Subject: AP1000 Response to Request for Additional Information (SRP 6)

AP1000 TECHNICAL REPORT REVIEW

Response to Request For Additional Information (RAI)

Figure 1: Recirculation Flow Paths with RNS in operation.

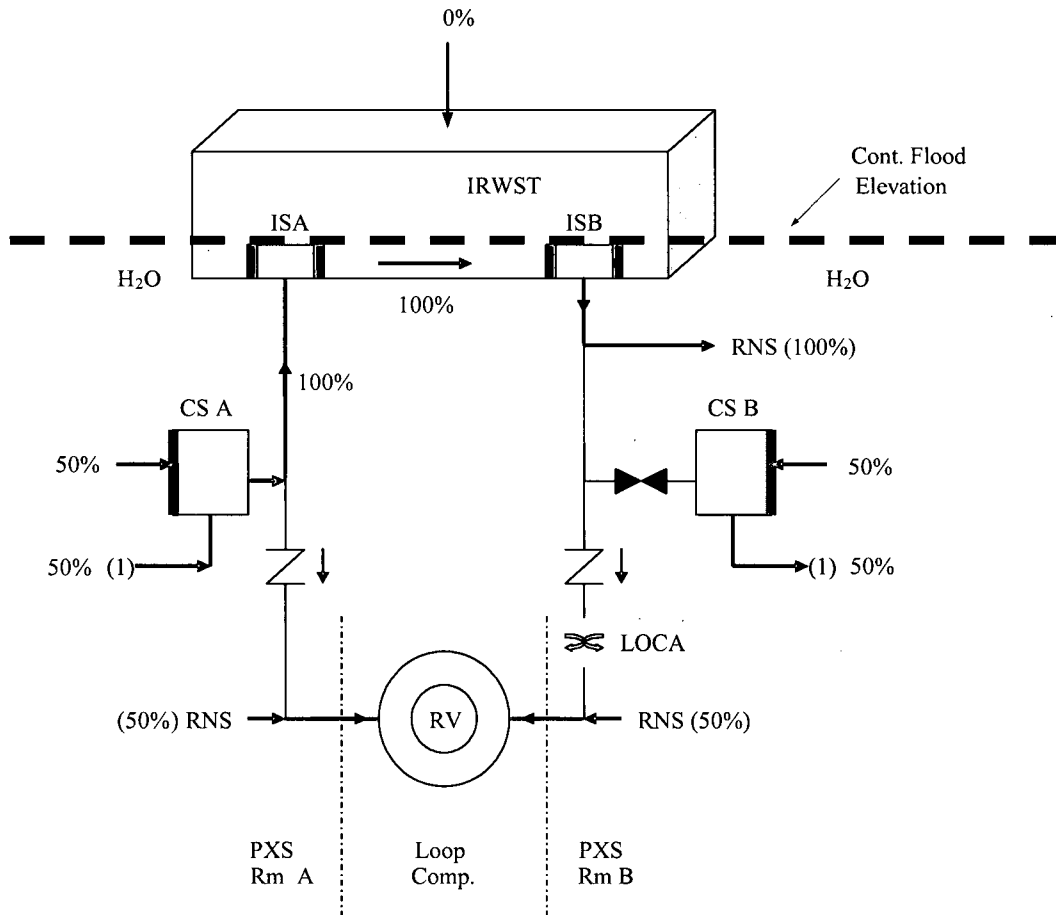
- c. The response to RAI-SRP6.2.2-SPCV-07(d) states the head loss test flow rates bound the operation of the non safety systems, but no details were provided. What are predicted maximum flows through IRWST and recirculation screen with and without RNS operation? How are these flows bounded by the head loss testing? Explain why 1200 gpm max IRWST flow is identified in Table A.1-1 of WCAP-16914-P but 1260 gpm max IRWST flow is identified in response to RAI-SRP6.2.2-SRSB-02.

Figure 1 provides a graphical representation of post LOCA long term core cooling with RNS operation. A PXS room B break is selected because it results in the flooding of that room which is assumed to result in failure of the two recirculation squib valves associated with the recirculation flow path to this PXS subsystem. As a consequence, the flow

through one IRWST screen is equal to 100% of the RNS flow. It should be noted that it was conservatively assumed that with the injection of subcooled water from the RNS assuming its heat exchangers are being cooled, that the ADS 4 vent flow is 100% water. As a result, all the ADS 4 vent flow is returned to the RCS through the containment recirculation screens which maximizes flow.

The RNS pumps can inject a maximum of 2400 gpm into the RCS with worst case assumptions which include the RCS at atmospheric pressure, no throttling of the RNS, and maximum pump head. However, in this situation the RNS pumps will cavitate. To prevent this cavitation the pumps are required to be throttled to ≤ 548 gpm which is consistent with the maximum PXS flow. Note that if the RNS can not be limited to this flow then the pumps will be stopped. Table 1 summarizes the flow rates for recirculation with and without RNS operation.

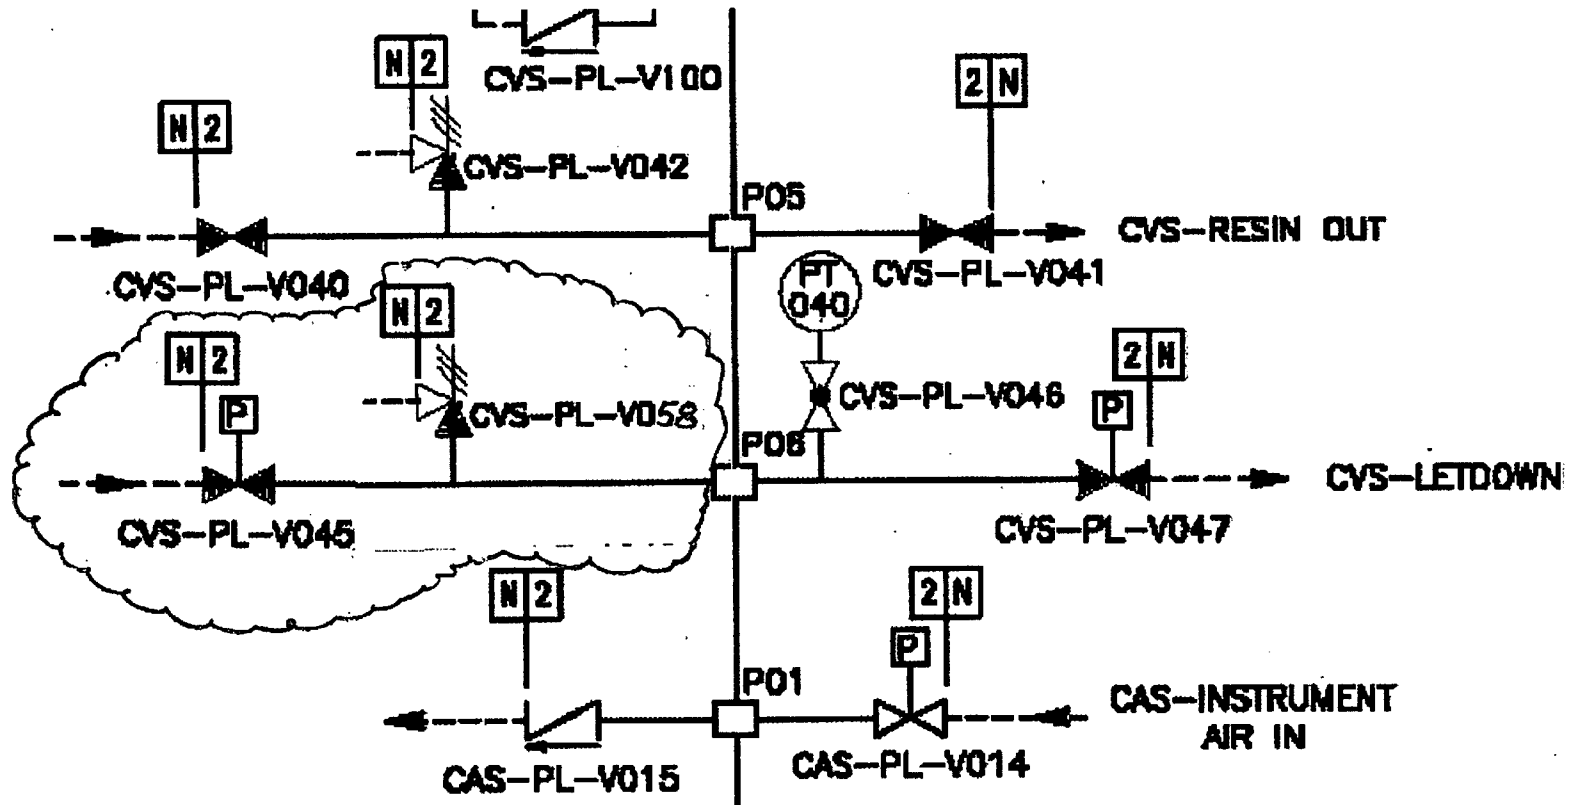
1. Confirm that these four valves comply with the SRP 6.2.4 acceptance criterion of having a setpoint greater than or equal to 150 percent of the containment design pressure.
2. Also, address why the CVS letdown line at penetration P06 has not been similarly provided with an overpressure relief valve between the two normally closed containment isolation valves, CVS-PL-V045 and CVS-PL-V047. If overpressure protection is provided, identify the overpressure relief valve in Tier 1, figure 2.2.1-1, Tier 1, Table 2.2.1-1 and Tier 2, Table 6.2.3-1.

2. Relief valve CVS-PL-V058 has been approved to be incorporated into the design of the CVS Letdown Line. This relief valve functions to provide thermal over pressure relief due to over pressure caused by thermal expansion in the penetration. The valve is installed in containment downstream of valve CVS-PL-V045. DCD markups showing the required changes are provided.

The following DCD sections are affected by the addition of relief valve CVS-PL-V058:
